Subject: Comments regarding Version 6.0 Draft 3 Computer Specification

The Natural Resources Defense Council (NRDC) respectfully submits the following comments in regards to the ENERGY STAR Version 6.0 Draft 3 Computer Specification issued November 29, 2012 and addendum dated January 3, 2013.

Figure 1: Pass Rate Trend 2010-2012 – Traditional Desktops

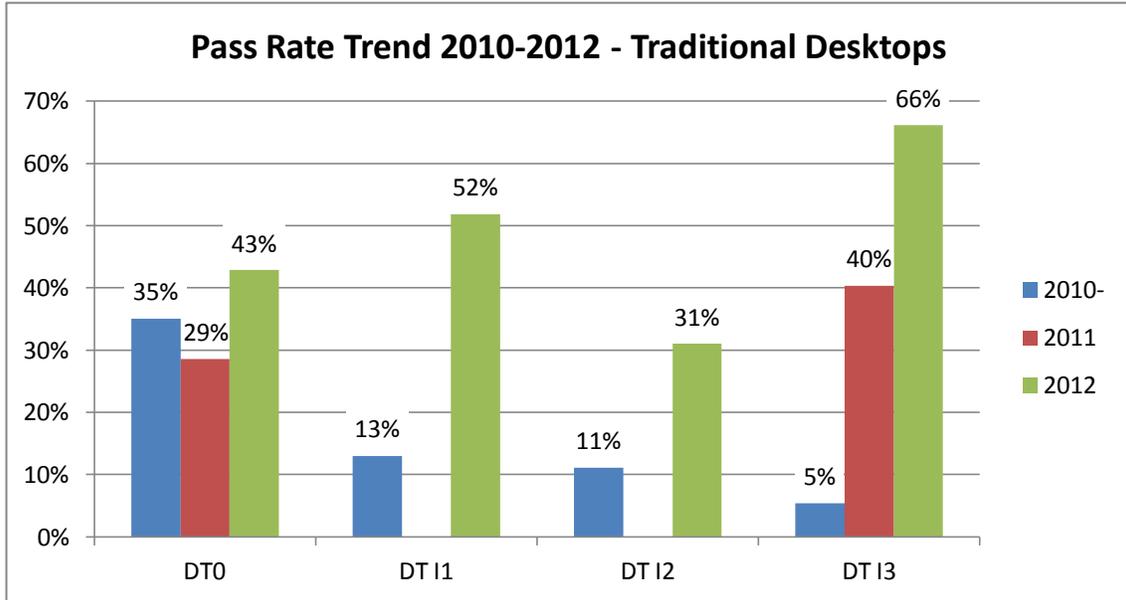
2012 computers are significantly more energy efficient than 2010 and 2011 models. V6.0 energy limits should be based on 2012, or at most 2011 and 2012 models.

The charts below show the improvement trends in pass rates for Draft 3 levels from 2010 to 2012. In each category, the pass rate for 2012 (green bar) is significantly higher than the pass rates for 2010 and 2011 (blue and red bars):

will be in effect in 2014 and 2015. V6 energy limits should be based on 2012, or at most 2011 and 2012 models, not on 2010 models.

Figure 3: Draft 3 adders vs. 2011-2012 Test Data

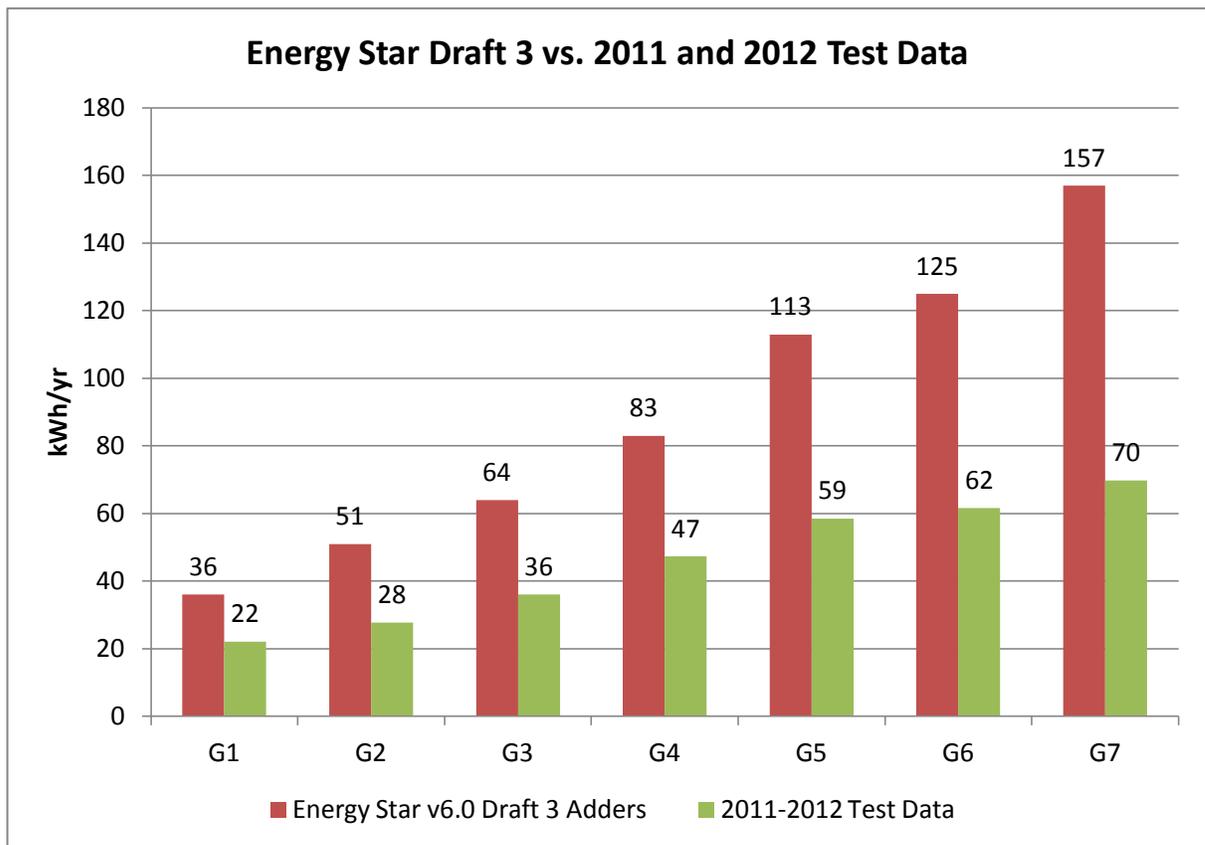
Draft 3 proposed graphics adders are nearly twice as high as justified by 2011-2012 market data. This creates a very large unwarranted allowance, especially in the G5-G7 graphics categories.

Draft 3 proposed adders (in red) are approximately twice as high as the data of both studies, and more than twice as high as the 2012 data alone.

NRDC recommends that graphics adders be aligned with the combined 2011-2012 test data. 2011-2012 data is the most representative of graphics technology that will be on the market in 2014 and 2015 when the specification will be in effect.

Figure 4: 2011 and 2012 Graphics Test Data

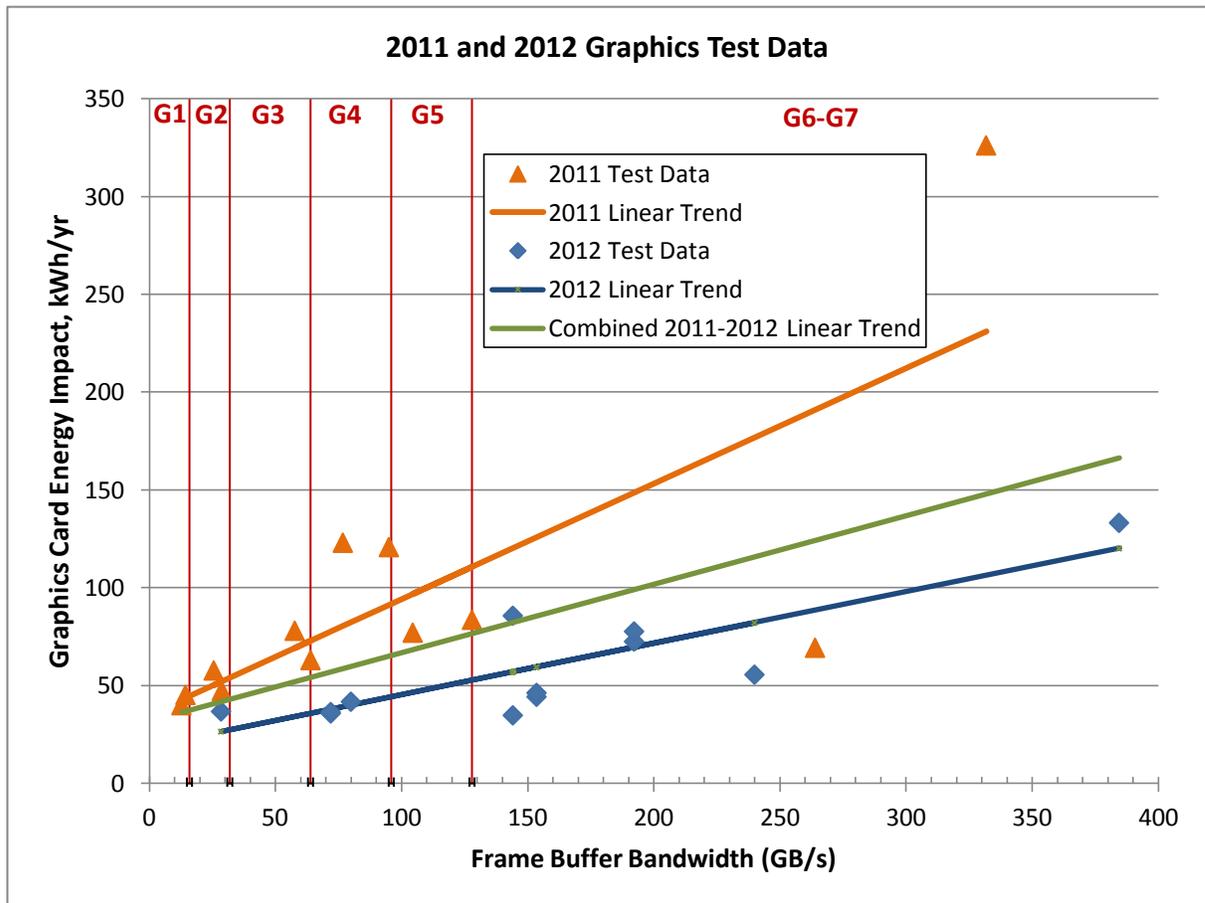
Figure 4 below shows the dramatic improvements in energy efficiency of 2012 (blue line) vs. 2011 (orange line) graphics technology. The green line represents the linear trend of the combination of 2011 and 2012 data.

EPA could justifiably base Version 6.0 on 2012 data alone (blue line), as this represents a broad sample of products already available in the market today, and will be the majority of the market in 2014 and 2015. However, in the spirit of compromise, NRDC proposes to set Version 6.0 levels based on the combined 2011-2012 test data (green line), as represented by the table at the end of this section. This constitutes a data set of 24 graphics cards which represents approximately one third of GPUs introduced on the market over the 2011-2012 period.

The combined results show that the power requirements of G7 graphics cards in idle mode and the resulting impacts on system typical energy consumption are much lower than the proposed Draft 3 adder, by as much as 33 kWh/yr for 2011 and 87 kWh/yr for 2012 cards. To put this in perspective, 87 kWh/yr is higher than the base allowance for category DT1 desktop! This would essentially be a free giveaway to systems that use 2012 or later G7 cards, which will be most or all of the G7 cards sold by the specification's effective date.
